PRODUCT CHANGE NOTIFICATION

Product Category POWER CONNECTORS **20211116-1**

Product Group POWER CONNECTORS GROUNDING AND STEEL

ISSUE DATE: 16-Nov-21

Photos/Drawing (where applicable)

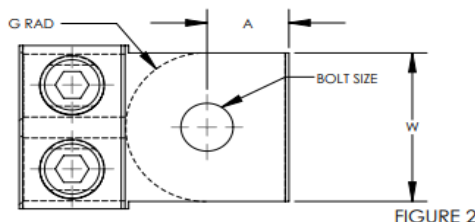
The stud hole 'A' Dimension from the front of the LAM2A250-38-6Y Aluminum Mechanical Lug will be adjusted from .51 (13.0) to .89 (22.5). This will be a running change.
